URBAN PLANNING DELEGATED COMMITTEE

3.1 48-52 Riversdale Road, Hawthorn - Four storey apartment building - PP23/0152

PLANNING ASSESSMENT

Application Number	PP23/0152
Date Application Received	08/03/2023
Planning Officer	Jock Farrow
Applicant	SP16 Pty Ltd
Property Address	48-52 Riversdale Road, Hawthorn
Proposal	Construct multiple dwellings on a lot and to create or alter access to a road in a Transport Zone 2; involving a 4 storey apartment building upon basement car parking
Ward	Riversdale
Zoning	Residential Growth Zone - Schedule 1 Adjoins Transport Zone 2
Overlays	None applicable
Neighbourhood Character Precinct	40
Particular Provisions	<ul style="list-style-type: none"> • Clause 52.06 (Car Parking) • Clause 52.29 (Land Adjacent to the Principal Road Network) • Clause 53.18 (Stormwater Management in Urban Development) • Clause 55, including 55.07 (ResCode & Apartment Developments)
Permit Triggers	<ul style="list-style-type: none"> • Clause 32.07-5 (RGZ) of the Boroondara Planning Scheme, a permit is required to Construct two or more dwellings on a lot. • Clause 52.29 of the Boroondara Planning Scheme, a permit is required to Create or alter access to a road in a Transport Zone

Figure 1: Extract North Elevation (TP-10) showing encroachment into B17 profile.

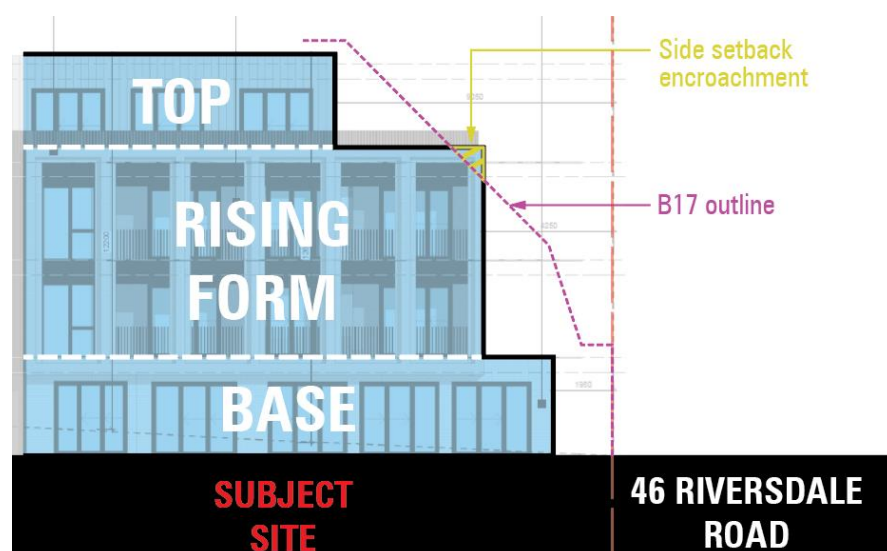
- Concern, however, is raised with the encroachment of APT 207 into B17, which will negatively impact up the amenity to the west.
- The Existing Conditions plan (TP-01) shows a 6.7m setback to the west (1/46 Riversdale Road) and a 7.6m setback to the east (60 Riversdale Road) resulting in a preferred front setback of 7.15m. In the absence of any clear justification for encroachment into the setback Standard B6, we recommend a minimum front setback of 7.15m be provided to the northern façade.

Figure 3: Extract Ground Floor Plan (TP-05) showing potential adjustments to APT G04 and APT G05 open space and interface treatment.

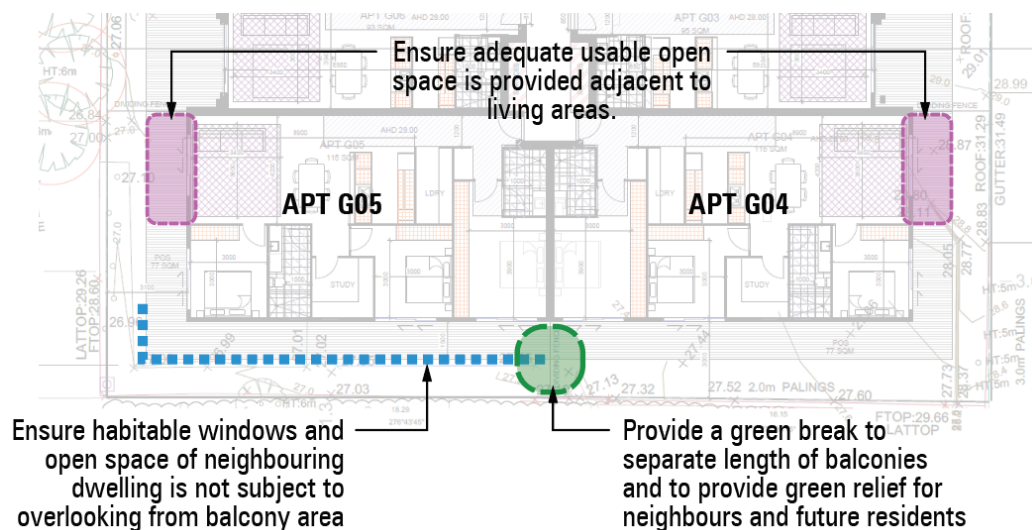
would offer welcome visual relief to neighbours (south) and future residents (APT G04 & APT G05).

Tree 11 - Proposed TPZ/SRZ encroachment (ramp/driveway)

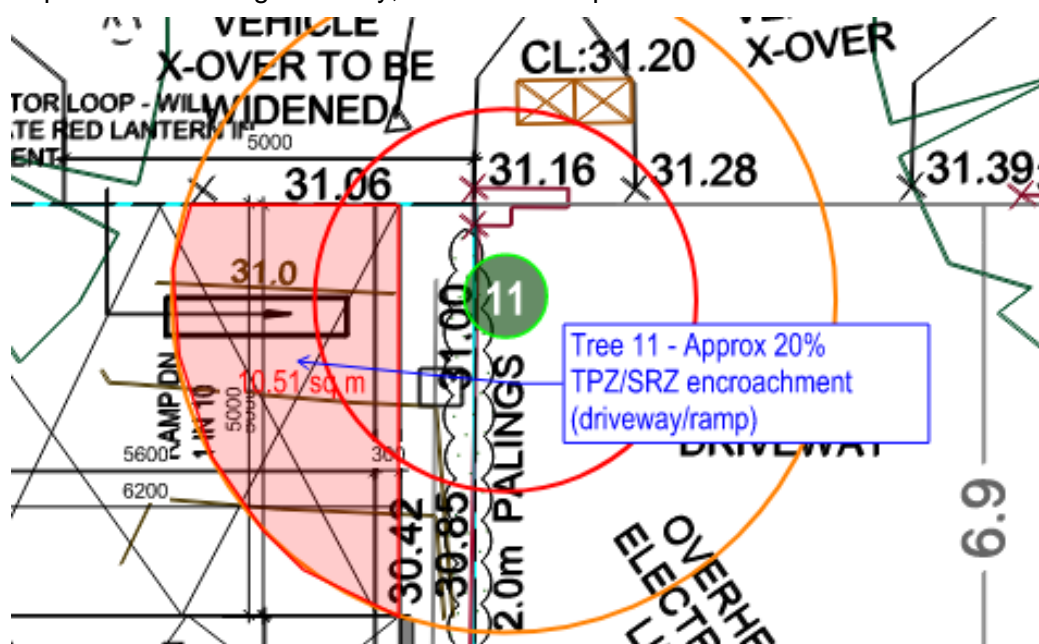
This neighbouring tree is located directly adjacent to the eastern boundary fence and has not been surveyed as part of the plans. The proposed ramp will represent a major encroachment of the TPZ and SRZ which is likely to have major impacts on the tree. The driveway/ramp within the TPZ/SRZ of this tree must be constructed above grade, or at the depth of the existing driveway, and consist of permeable materials.

Tree 15 - Proposed TPZ encroachment (basement and decking)

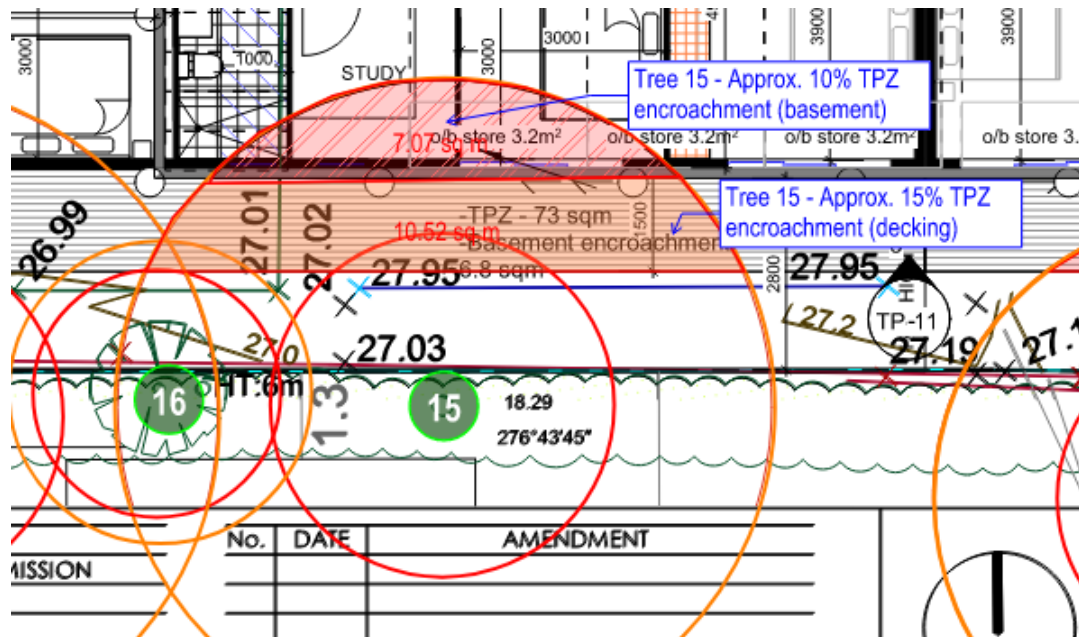
The proposed basement represents a TPZ encroachment of approx. 10% which is considered minor and unlikely to impact the tree. The proposed decking area represents a further TPZ encroachment of approximately 15% which is considered major and has the potential to impact the tree. Given the species of tree it is unlikely to be impacted with decking to be constructed above grade, on root sensitive footings, and with a permeable design. Decking to be deleted within the SRZ of this tree.

Tree 17 - Proposed TPZ encroachment (dwelling/decking)

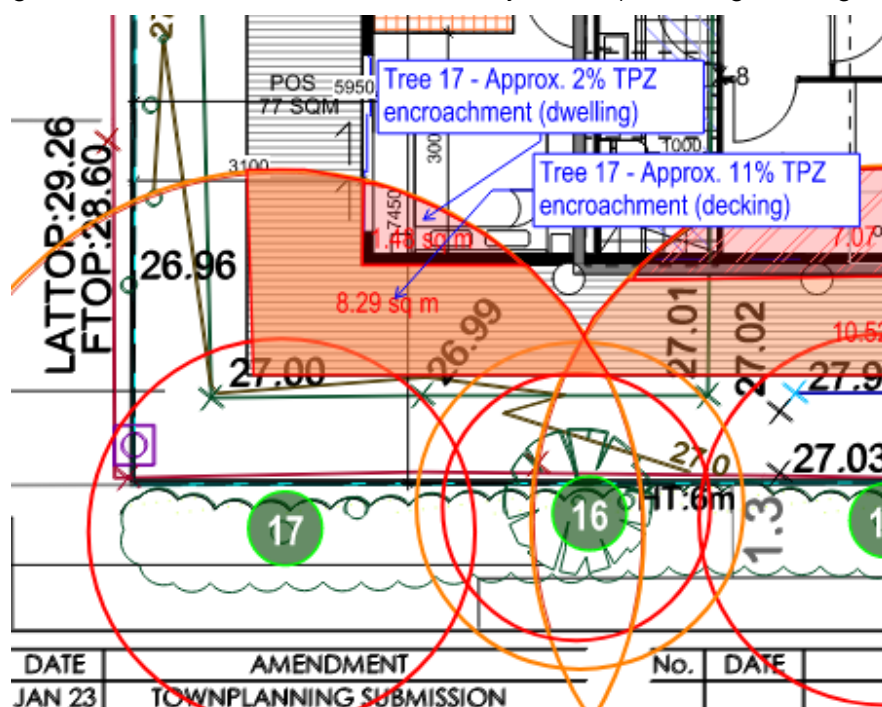
The proposed dwelling represents a TPZ encroachment of approx. 2% which is considered minor and unlikely to impact the tree. The proposed decking represents a further TPZ/SRZ encroachment of approx. 11%. Although the combined encroachment is marginally over what is considered minor, the proposed works are unlikely to impact the tree. The decking must be constructed above grade utilising root sensitive footings. Decking to be deleted within the SRZ. The TPZ area must be maintained at existing grade where it encroaches into the subject site (excluding building footprint).

Tree 24 - Proposed TPZ/SRZ encroachments

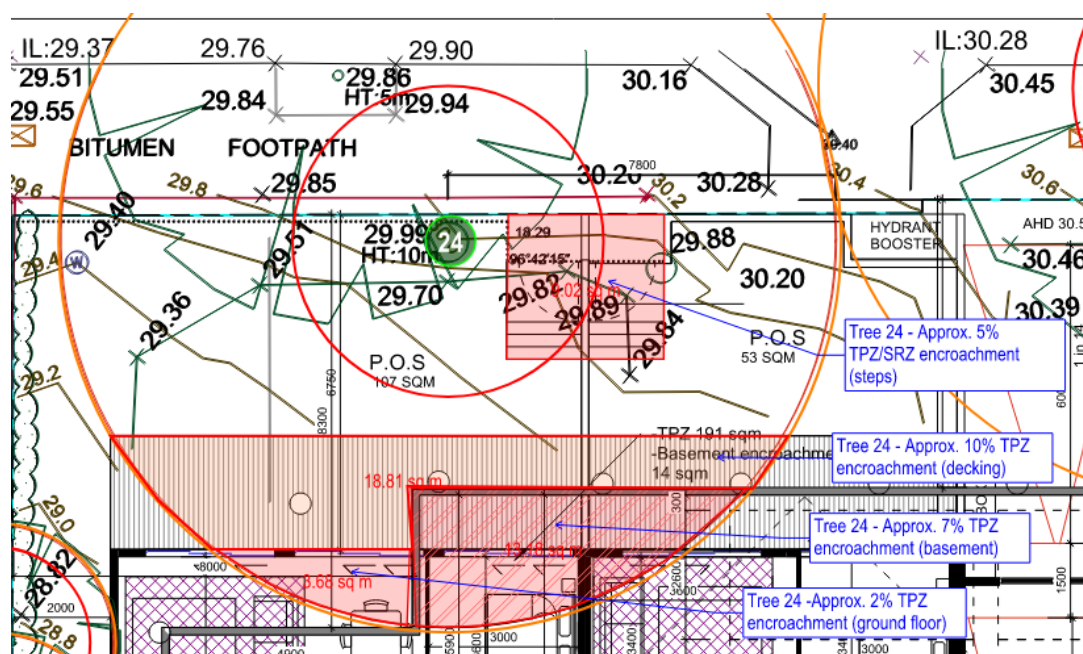
The proposed basement and ground floor footprint represent a TPZ encroachment of approximately 9% which is considered minor and unlikely to impact the tree. There is a

further proposed encroachment of approx. 10% by the decking, which is unlikely to impact the tree if constructed above grade, of permeable surface and utilising root sensitive footings. The construction of the steps within the SRZ and in such close proximity to the tree would not be supported. Any boundary fence construction requires the use of root sensitive footings, no strip footing.

- (p) Notation confirming that all fencing and decking structures within the TPZ of Tree 24 and all neighbouring trees to incorporate root sensitive footings or as otherwise agreed in the endorsed Tree Management Plan required by this Permit.

Figure 4 - Sectional diagram demonstrating overlooking measures from second floor terrace, toward the rear

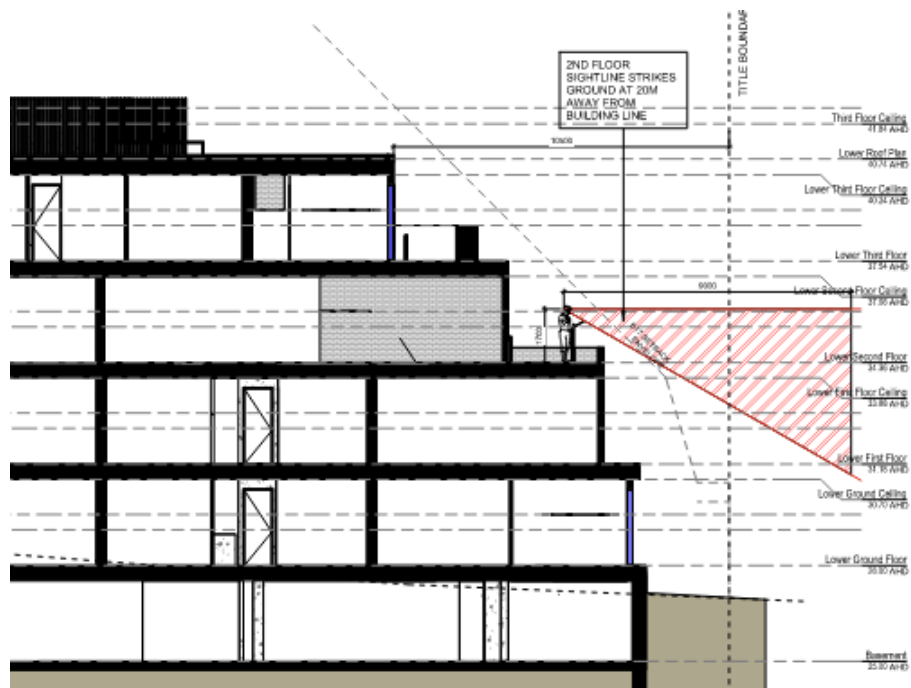
At second floor, the use of a 1.3m high angled balustrade is proposed. Overlooking diagrams demonstrate that there would be no undue overlooking to neighbouring SPOS areas. However, it appears that overlooking would occur to the neighbouring north facing window (within 3m of the common boundary). It is considered that this issue could be addressed by a permit condition.

Figure 5 - Sectional diagram demonstrating overlooking measures from second floor terrace, toward the west

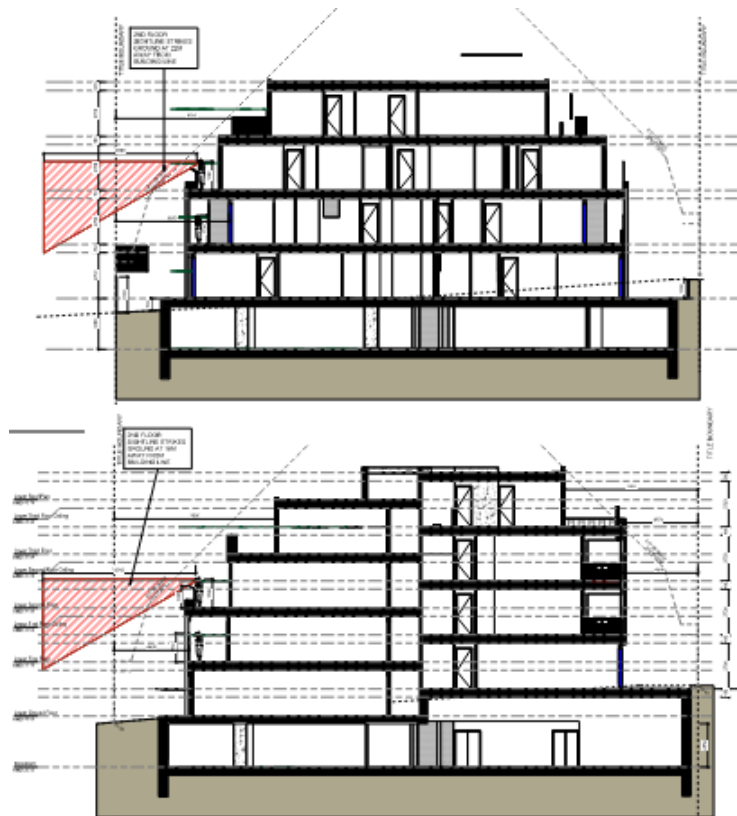
To the balance of the second floor, the use of a 1.3m high angled balustrade is proposed. As with the rear elevation, overlooking diagrams demonstrate that there would be no undue overlooking to neighbouring SPOS areas; however, it appears that there would be overlooking to neighbouring windows. It is considered that this issue could be addressed by a permit condition.

DRAWING NO:
TP-03
A1 size sheet:

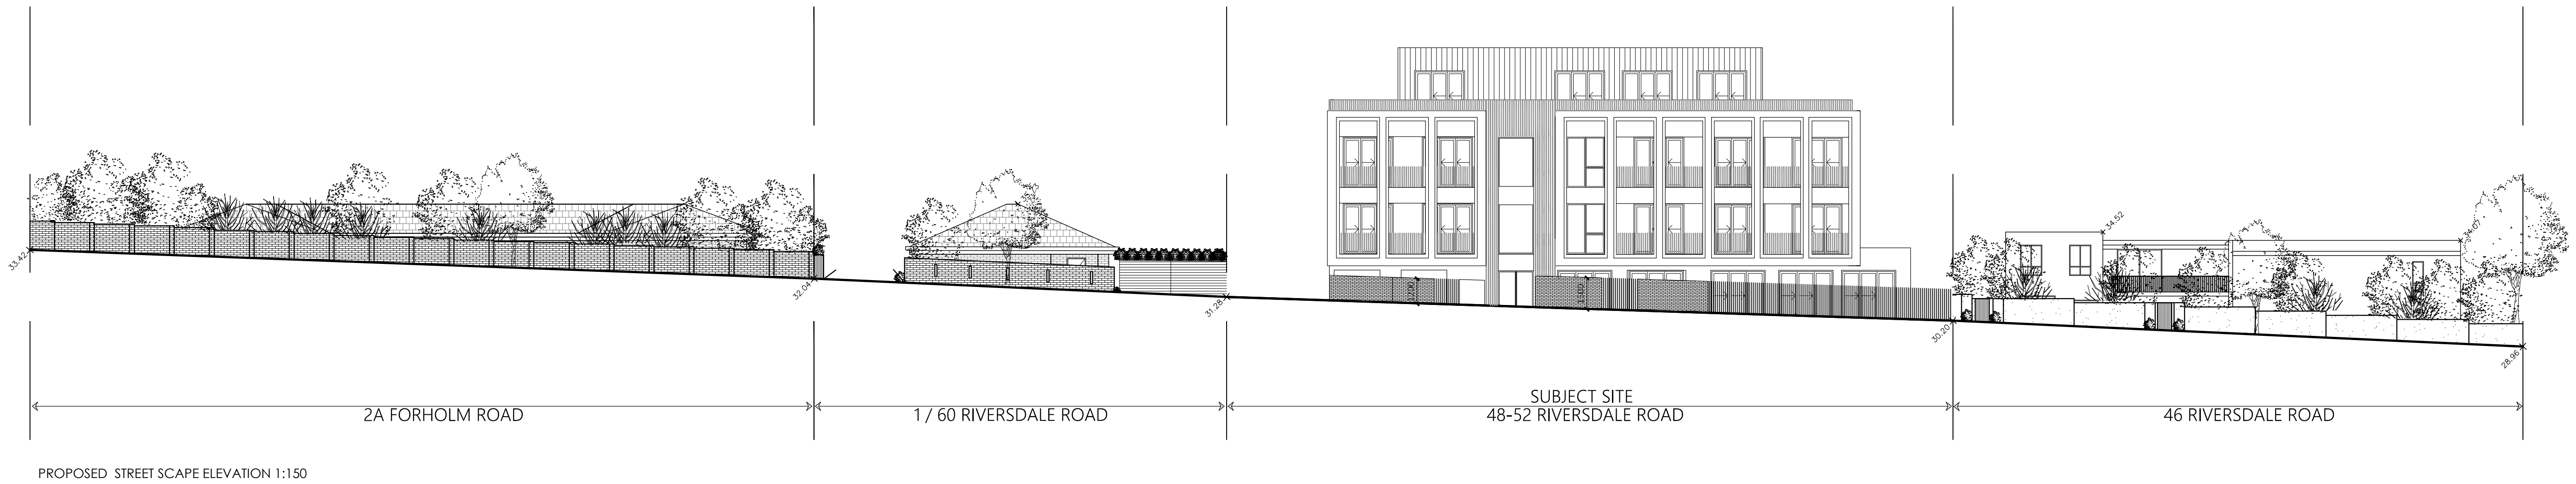
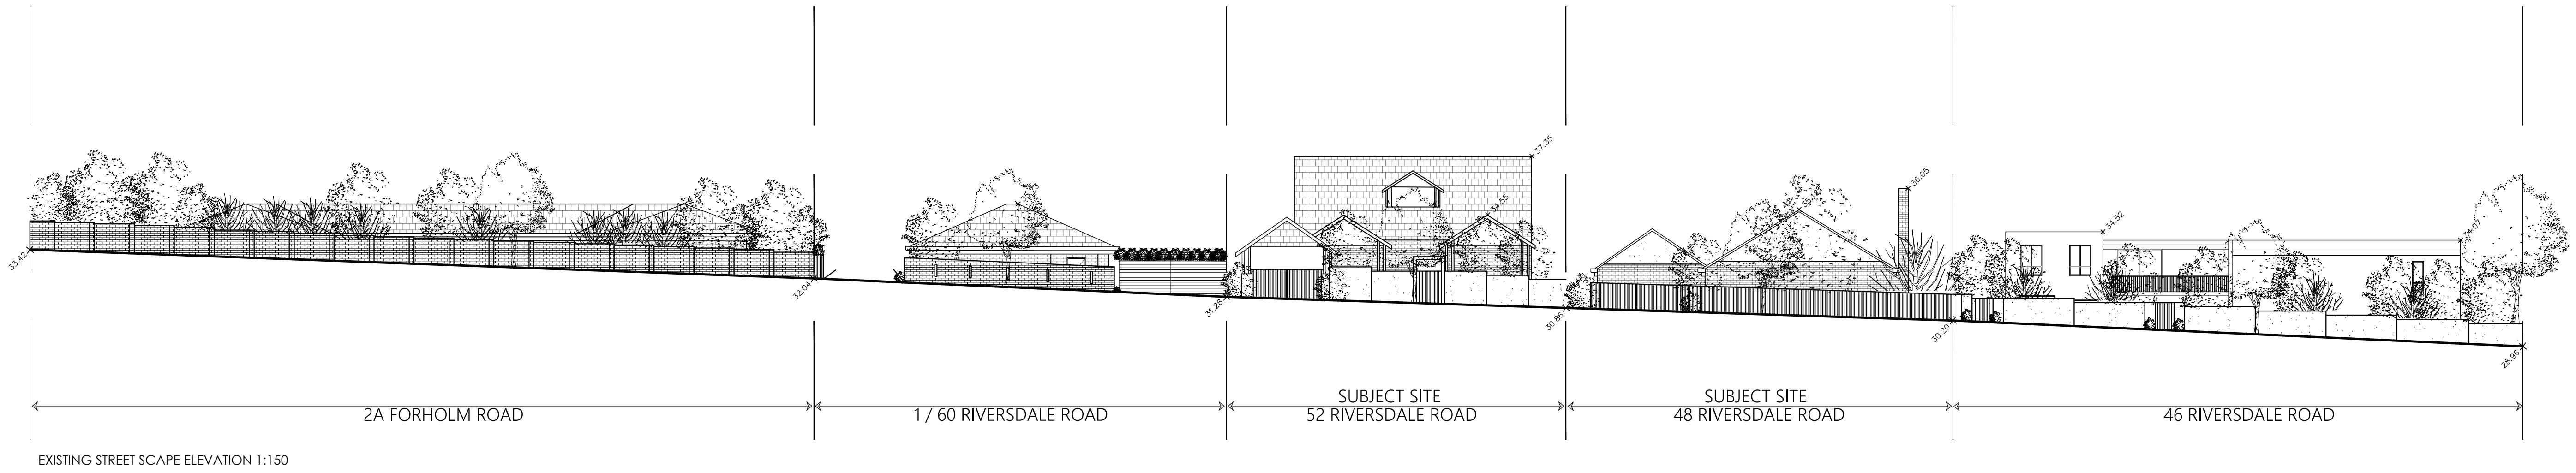
- 30. Prior to the occupation of the development the crossover driveway and all associated works show on plans (Pitard Group Ref TP-03 Rev 3 29/08/2023) must be constructed to the satisfaction of the Head, Transport for Victoria and the Responsible Authority, at no cost to the Head, Transport for Victoria.

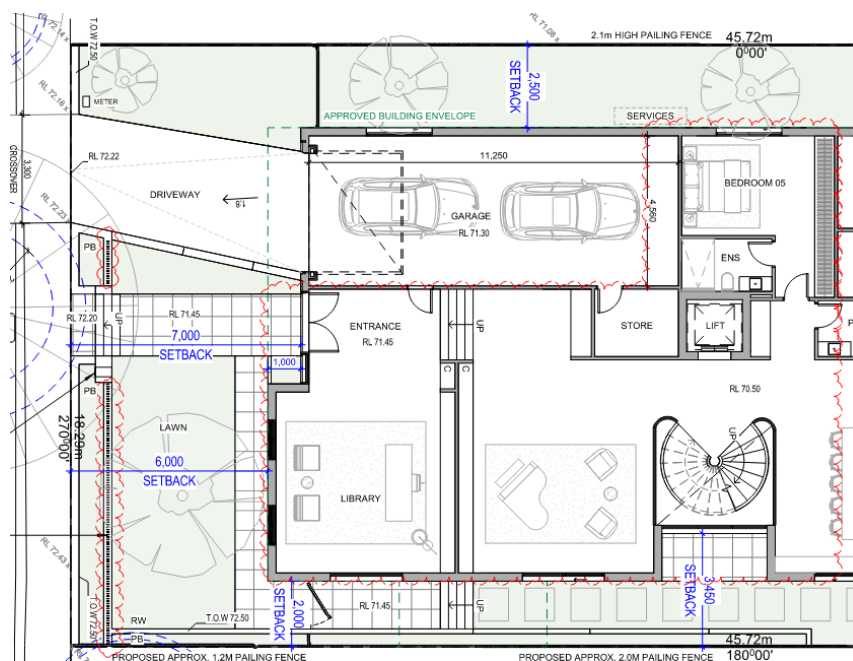
Modify the fence design and materiality to a simplified, contemporary style timber picket which maintains the approximate height, spacing and visual permeability of

traditional picket fences in the vicinity, e.g., nearby contributory property at 8 Cross Street.
